SAMPLE LOCATIONS FOR LOU #20, POND C-1 AND ASSOCIATED PIPING IN AREA III

Phase B Area III Source Area Investigation
Tronox Facility
Henderson, Nevada

SHEET NUMBER:	FIGURE NUMBER:
X	1

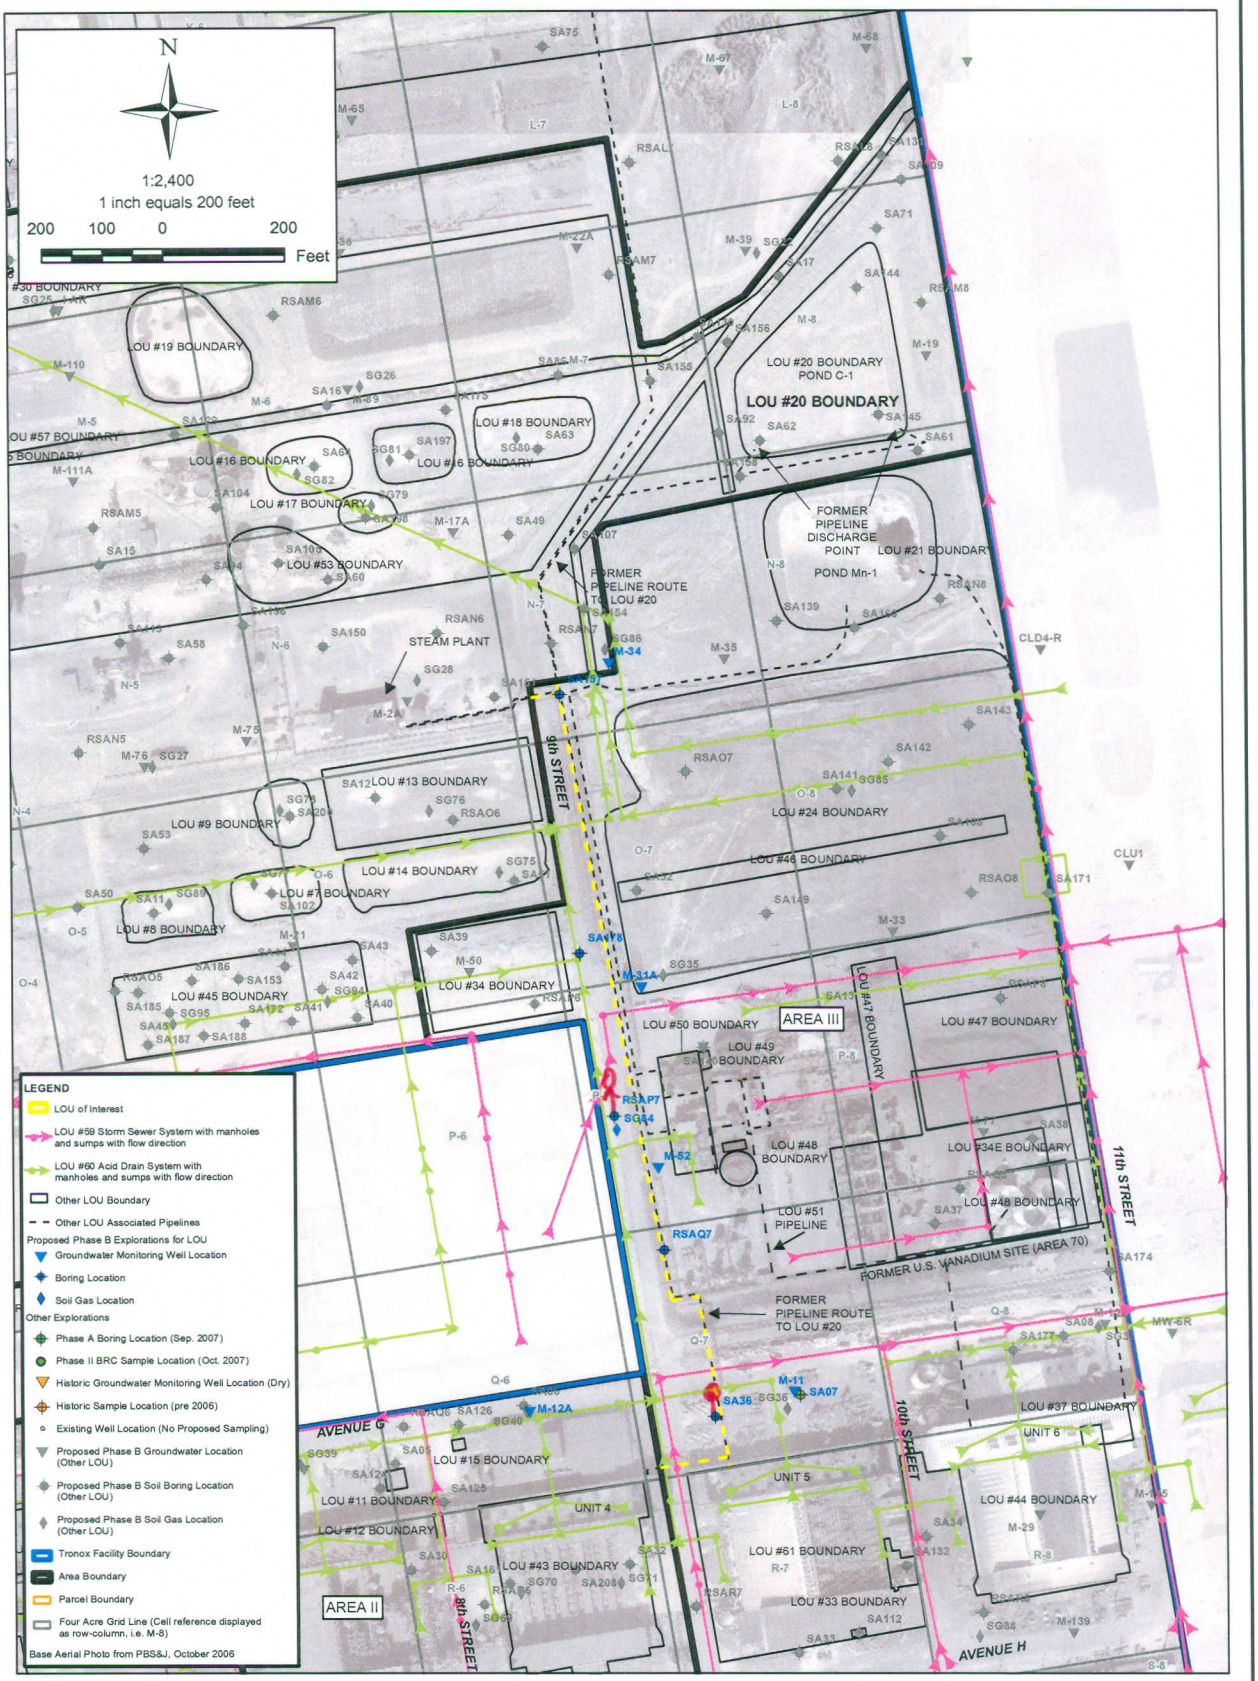
• move RSAP7 adjacent to LOU59 and near intersection with LOU60.
• move SA36 north to be over LOU60.
